Determination 2020/003

Whether a consented apartment building with a single escape route at 23 Clayton Avenue, Otara, Auckland requires smoke lobbies on the ground floor

Figure 1: Ground floor plan showing escape routes (not to scale)

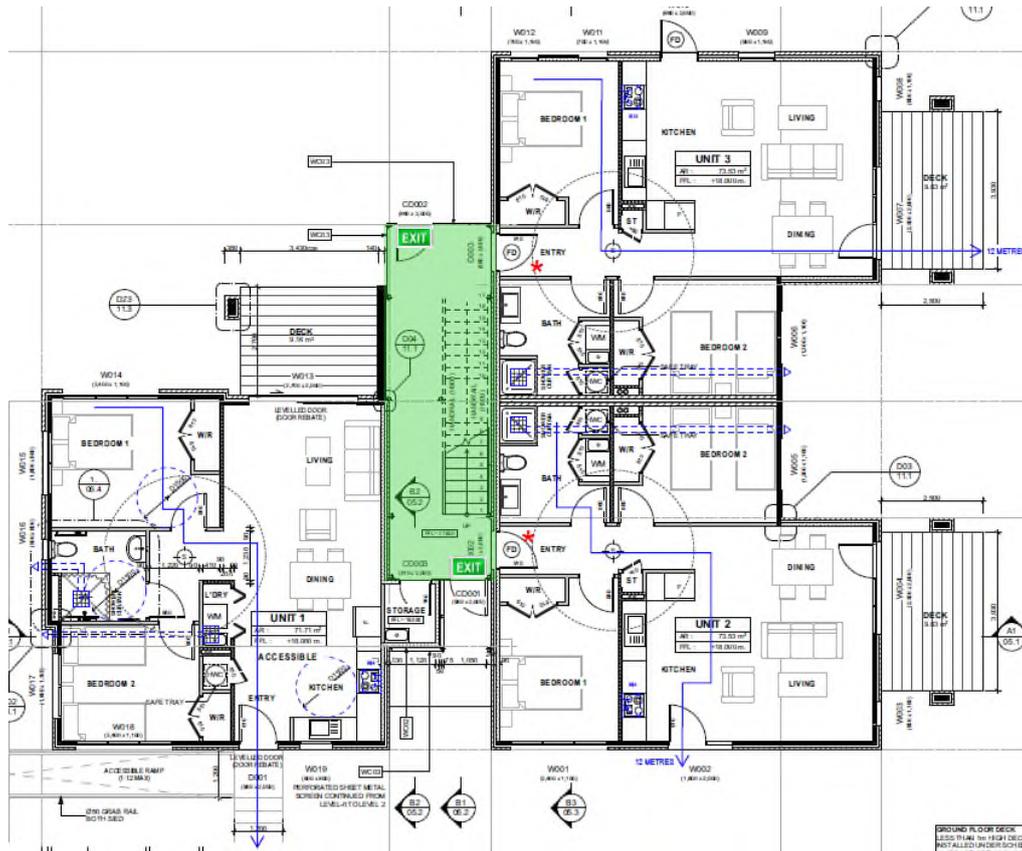
Note: doors into the common foyer area highlighted with a red asterisk. The “nominated escape routes” as a solid blue line.

- 5.5.2 As noted above and shown in Figure 1, occupants of the ground floor apartments have two external doors by which they may escape in the event of a fire, and two of the apartments (unit 2 and unit 3) also have doors that lead into the stairwell. As noted in paragraph 4.1.4, the applicant confirmed that the stairwell was not designed as an external escape route.

- 5.5.6 In the event of a fire in either of these two ground floor apartments, occupants of those apartments may choose to escape via the ground floor common foyer area. An open door in that situation could increase the potential for the effects of the fire, including smoke, to enter the stairwell safe path and this presents a life safety risk to those occupants of the upper levels whose single escape route is via the stairwell.

- 5.4.16 As there are no other paragraphs in C/AS2 that allow for an exception to paragraph 3.13.1(e), smoke lobbies are required within ground floor apartments preceding doors that lead into a vertical safe path (the common stairwell in this case) in order to comply by way of C/AS2.
- 5.4.17 The building as designed without smoke lobbies in units 2 and 3 on the ground floor is not in accordance with C/AS2 and therefore cannot be accepted as complying with Clause C4 by way of C/AS2. As set out in paragraph 1.1.3 of C/AS2, because the Acceptable Solution is not followed in full, either use of the Verification Method C/VM2 or an alternative solution will be needed to demonstrate compliance for this design.
- 5.4.18 I note for completeness that there are additional requirements set out in paragraph 3.13.4 for single escape routes in risk group SM. There are also requirements

Figure 2: First floor plan showing escape routes and smoke lobbies (not to scale)

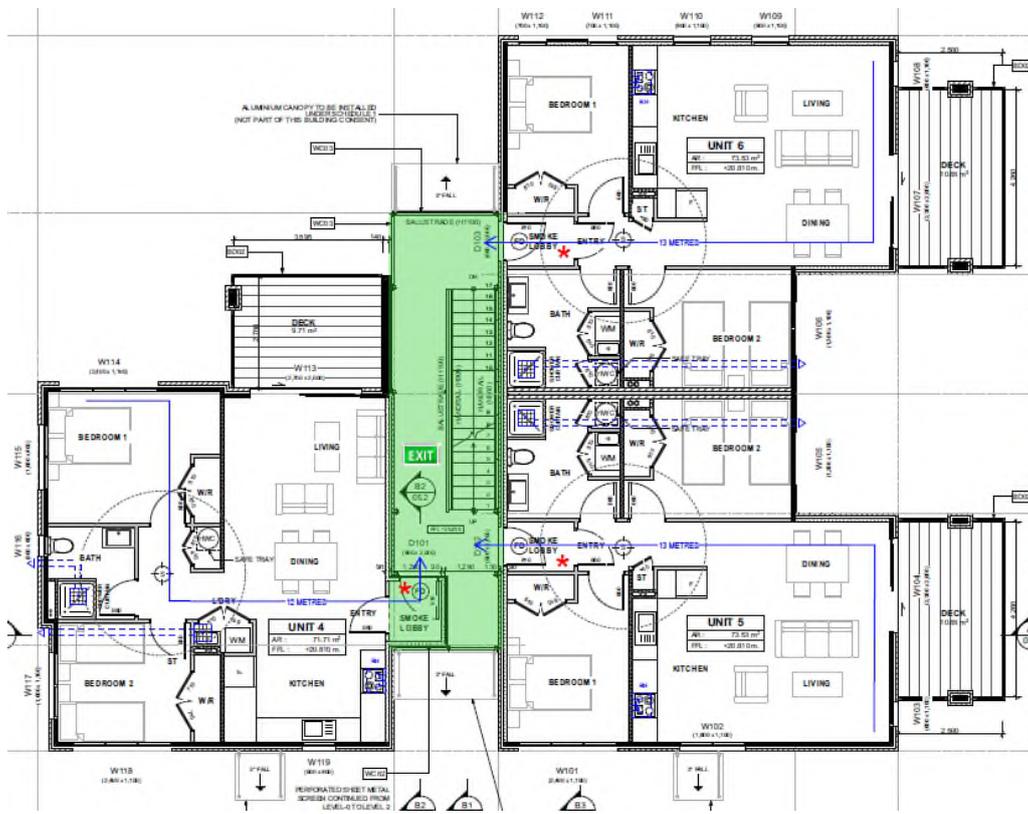
Note: smoke lobbies highlighted with a red asterisk.

However, the drawings included in the fire report show smoke lobbies only in the apartments on level one.

Figure 3: Perspective view showing the common stairwell (between the red lines) facing North West (not to scale).

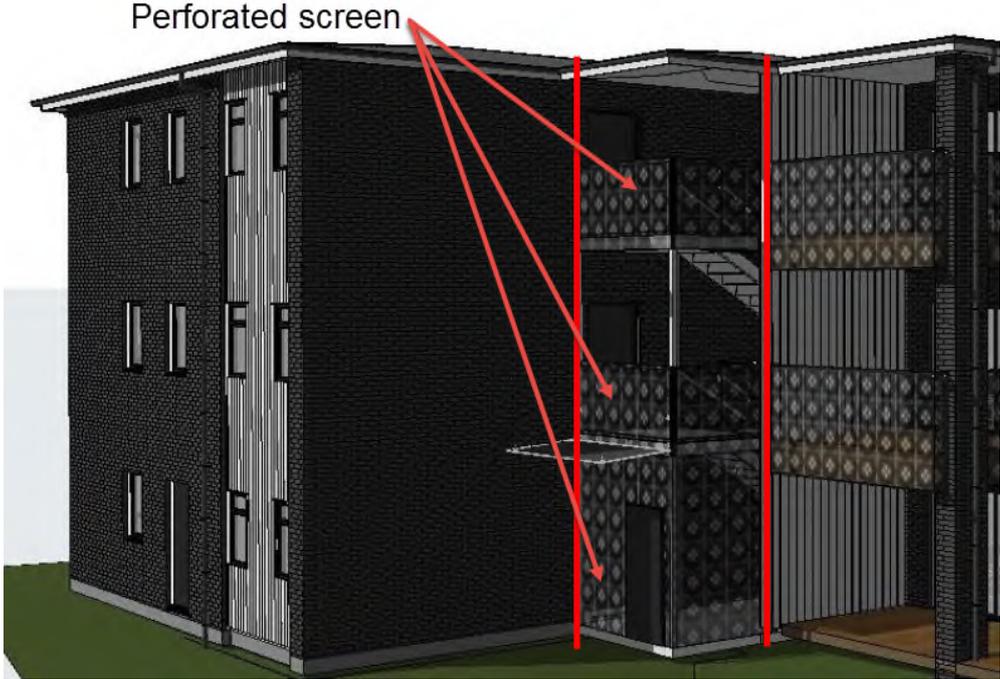
- 2.4.5 The common stairwell is encompassed by the external walls of the two blocks either side, which are fire separations, and is partially screened at either end (see Figures 3 and 4). The openings in the screen are at both ends of the common stairwell on level one and level two, with the screen forming a 1.1m high barrier to protect people from falling. The screen is made up of a perforated sheet metal.

- 2.4.6 On the south elevation the screen is full height at the ground level and level one, but is open approximately 1.4m (above the screen to the soffit level) on level two. On the north elevation the screen is full height on ground level, and is open approximately 1.4m (above the screen) on levels one and two. Gates made of the same perforated sheet metal are provided on the ground level at each end.
